SB, CYLINDER GASKET, K1270II Family, 2024-06

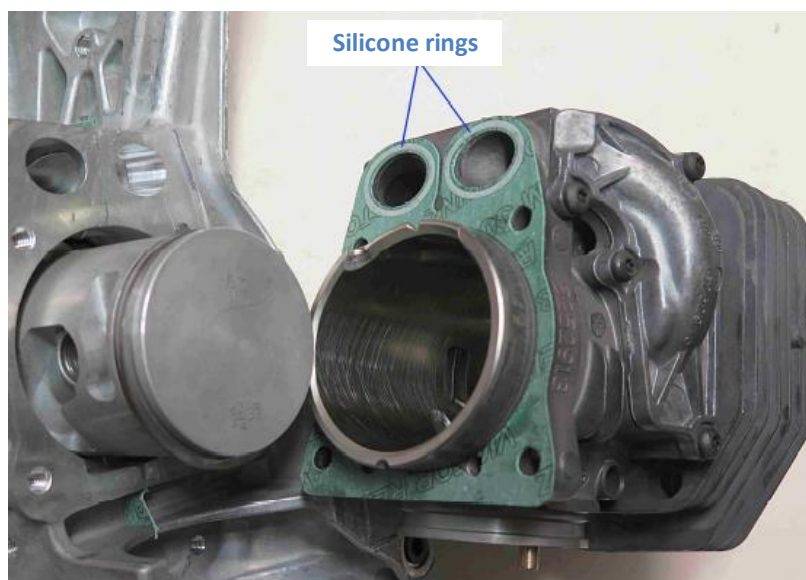
To improve the sealing between cylinder and crankcase, a new paper cylinder gasket with silicone rings has been developed.

When installing the new gasket, make sure the silicon rings on the gasket are facing the crankcase.
